The attention of bidders submitting proposals for the subject project noted above is called to the following Addendum to the Contract Forms and Specifications.

TWIN TOWERS MIDDLE SCHOOL

Sheet No. ASK-03

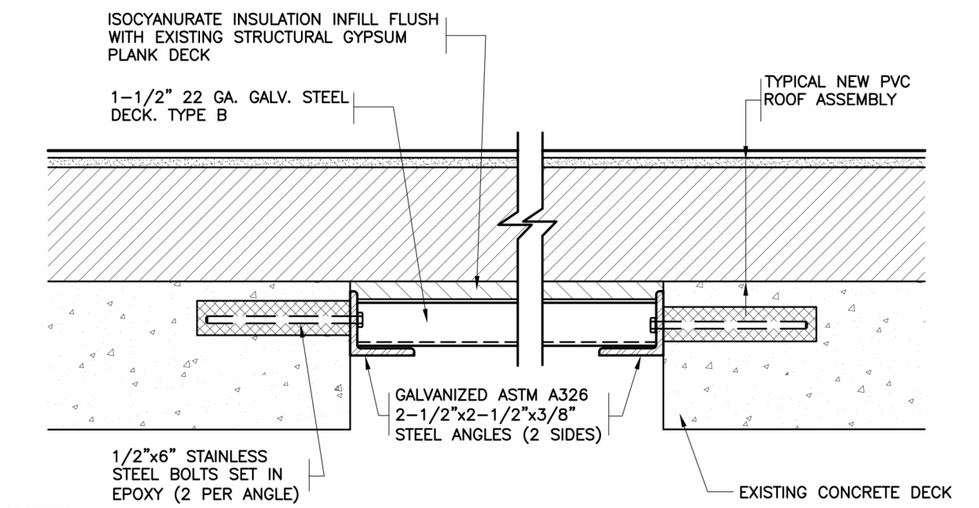
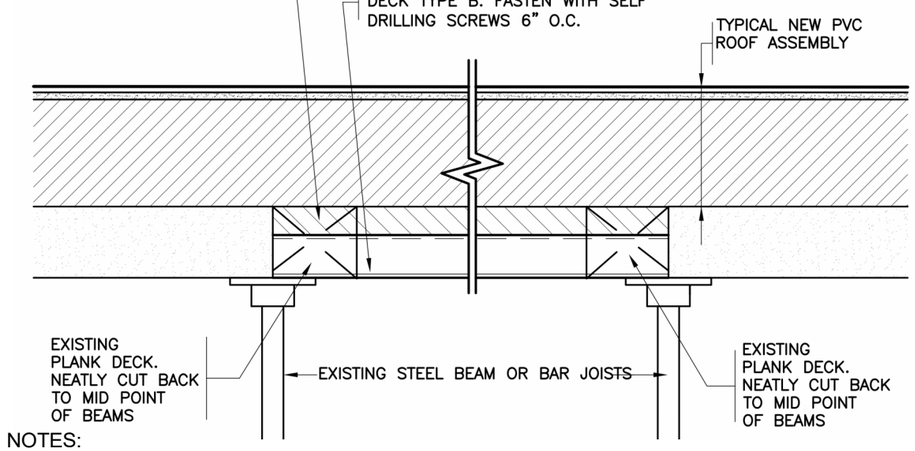
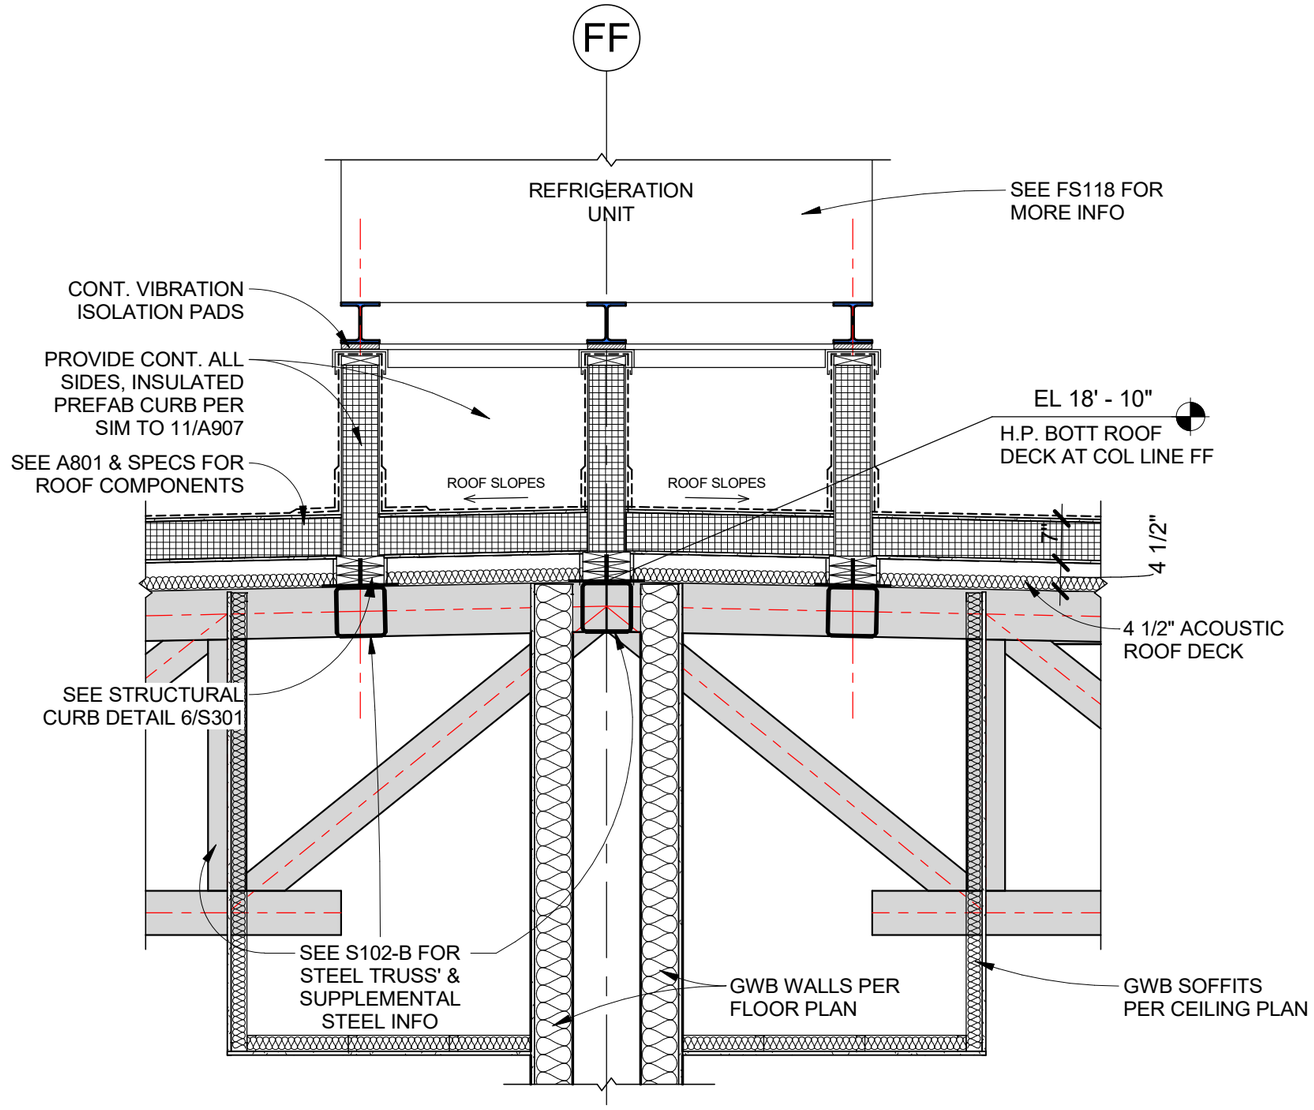
6) ASK-03
    a. ADD deck infill details & Section at refrigeration curb. See attached documents.

1 FIRE PROTECTION RISER DIAGRAM
NOT TO SCALE

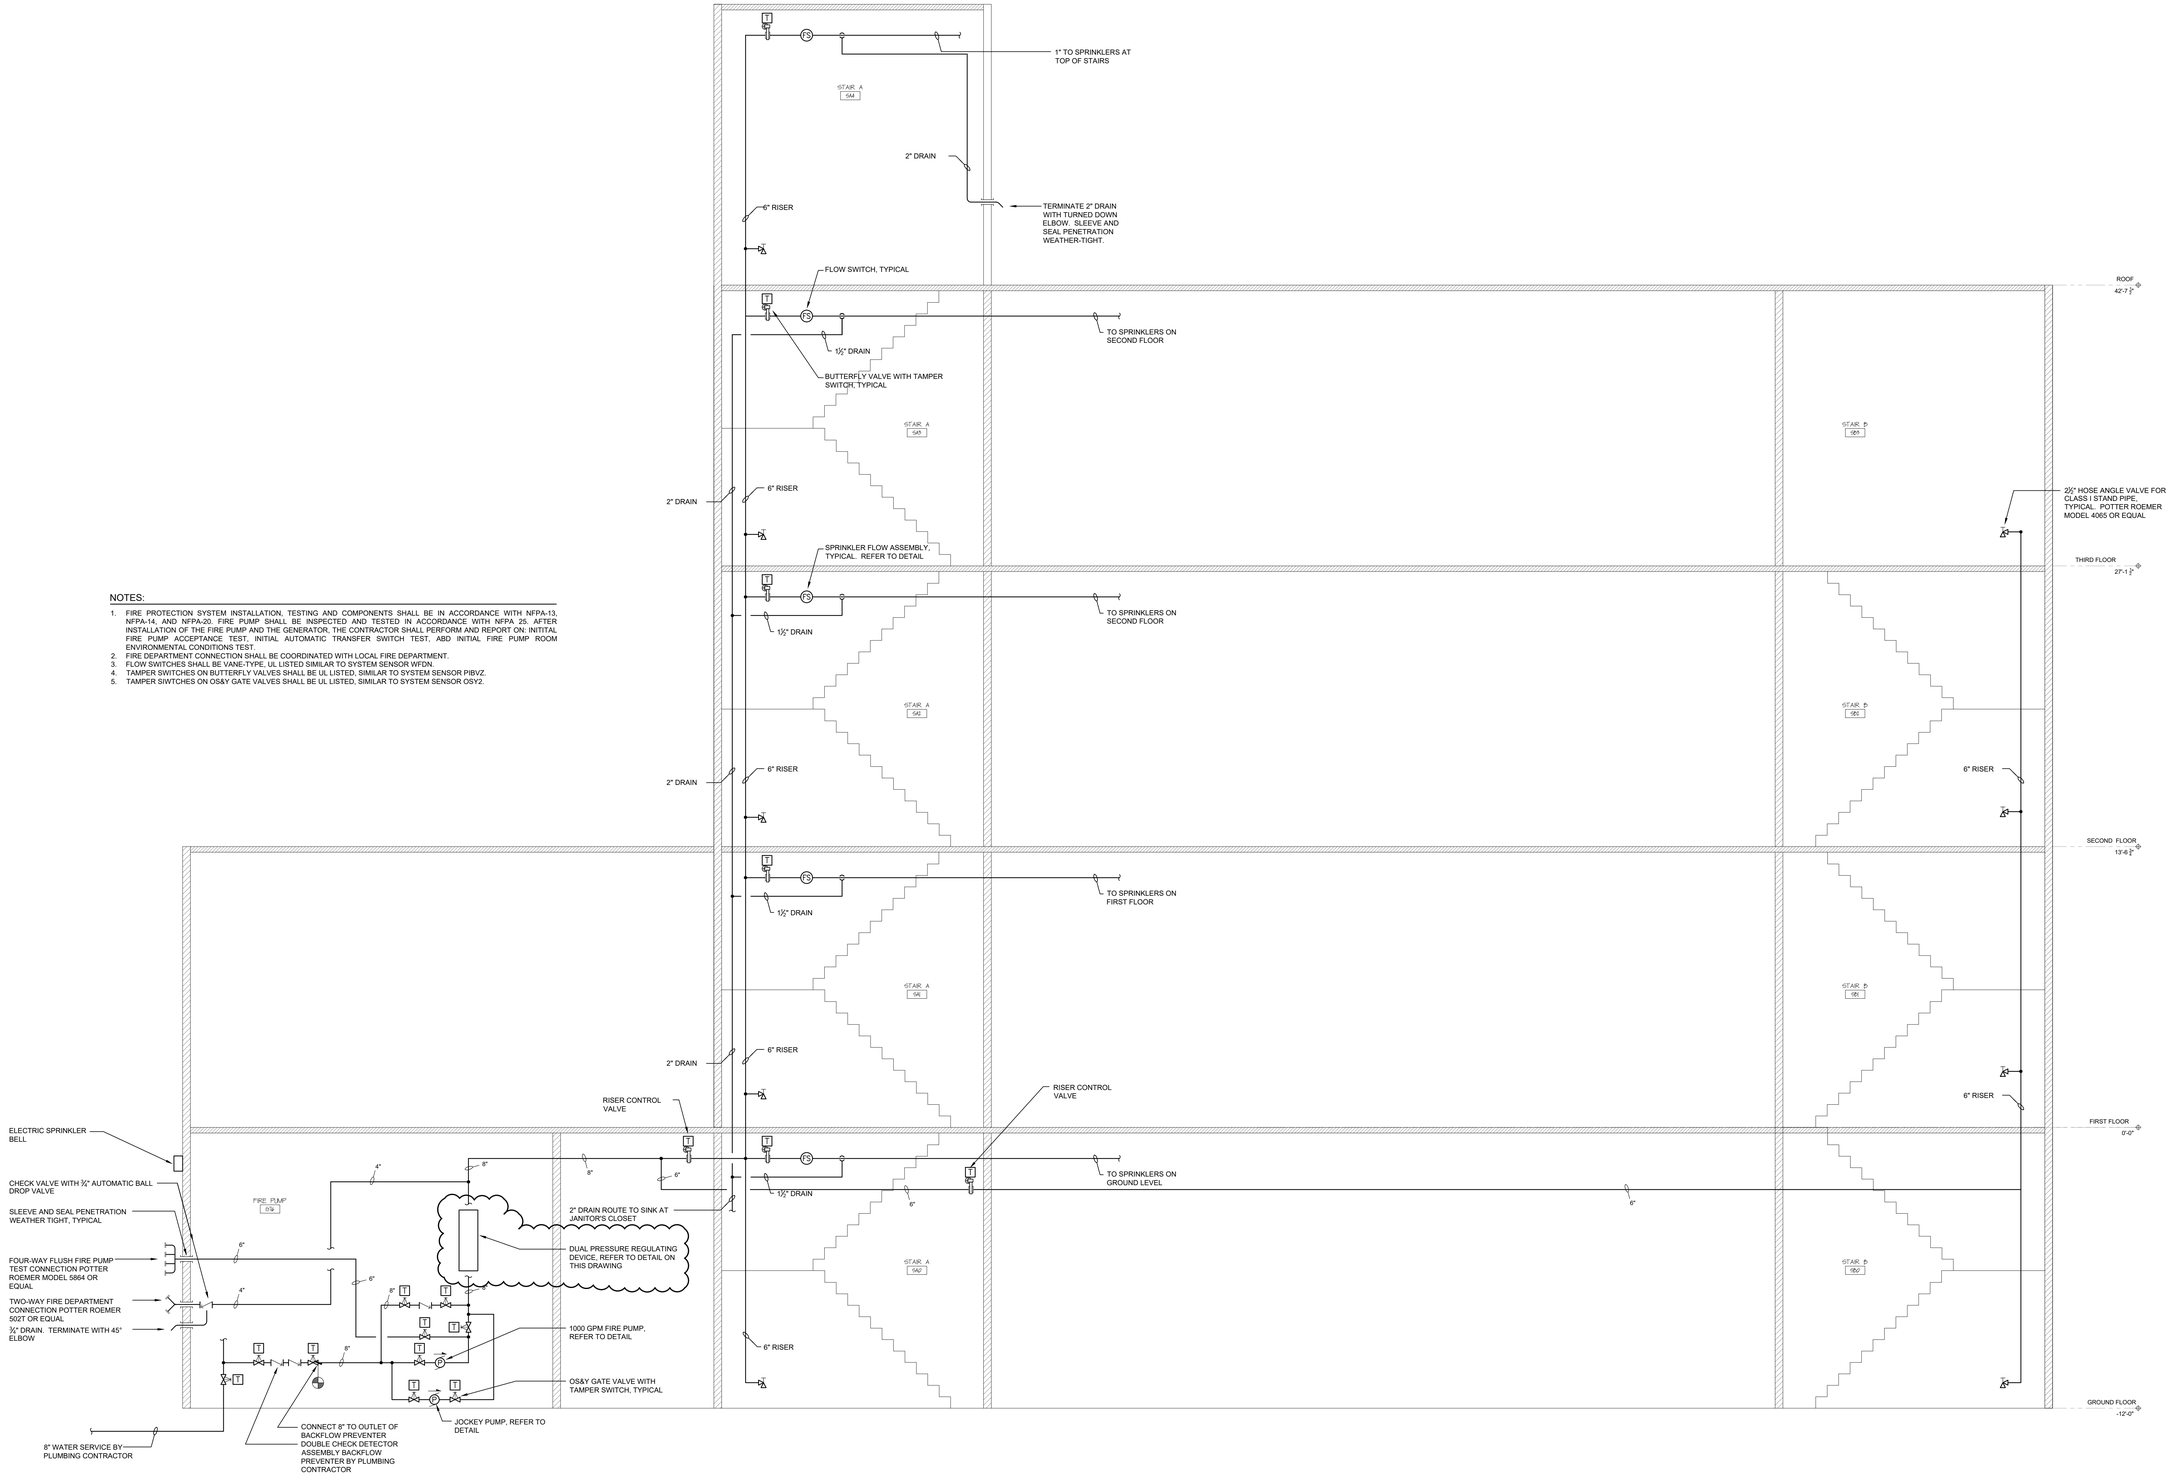
1) Drawing FP601 – Revised “Fire Protection Riser Diagram” to add dual pressure regulating device. Renumbered “Seismic Hanger Details” from #1 to #2. Added detail #3 “Dual Pressure Regulating Device”. Refer to revised drawing included with addendum.

1 ELECTRICAL DEMOLITION POWER SCHEMATIC

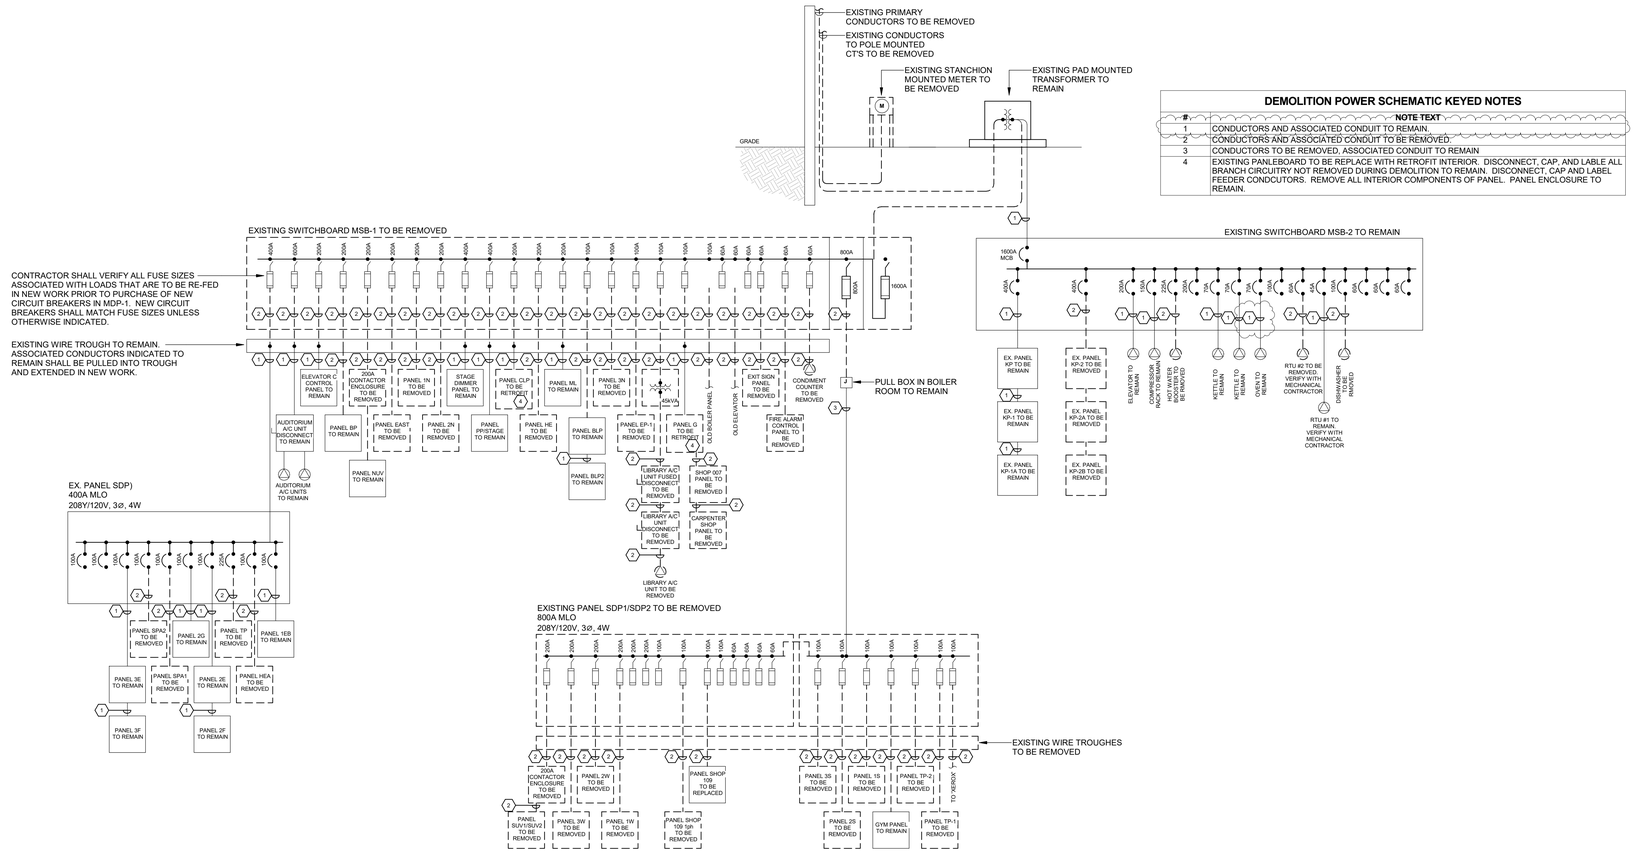
6) Drawing E601 – Revised Demolition Power Schematic Keyed Note #1 to read “Conductors and associated conduit to remain”. Refer to revised drawing included with addendum.

1 FIRE ALARM RISER DIAGRAM (1 OF 3)
NOT TO SCALE

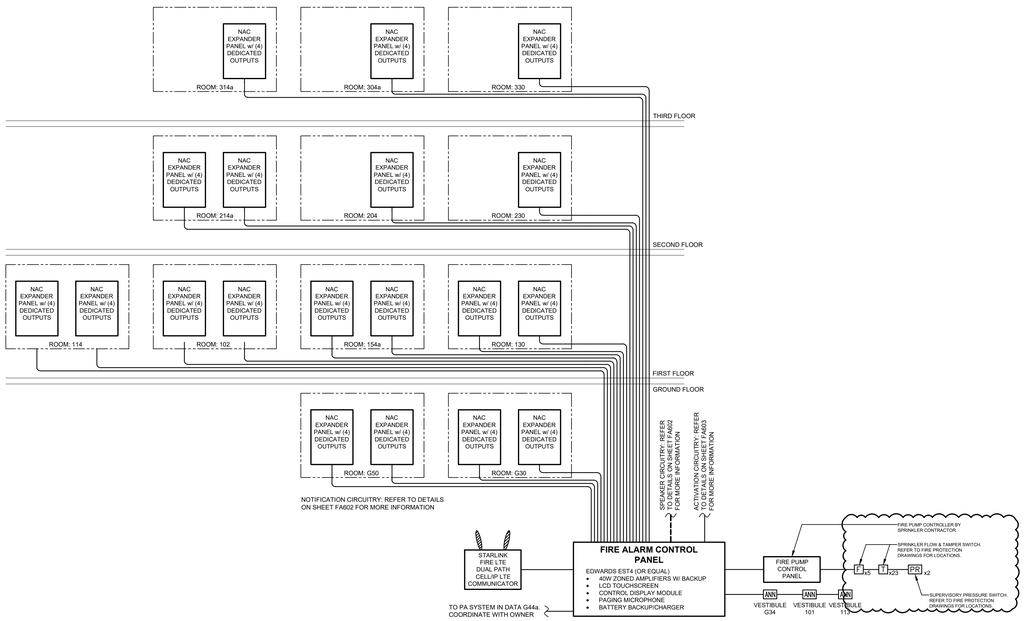
9) Drawing FA601 – Revised “Fire Alarm Riser Diagram (1 of 3)” to add sprinkler tamper and pressure switches. Revised “Fire Alarm System Input/Output Matrix” to add pressure switch to System Input column. Refer to revised drawing included with addendum.
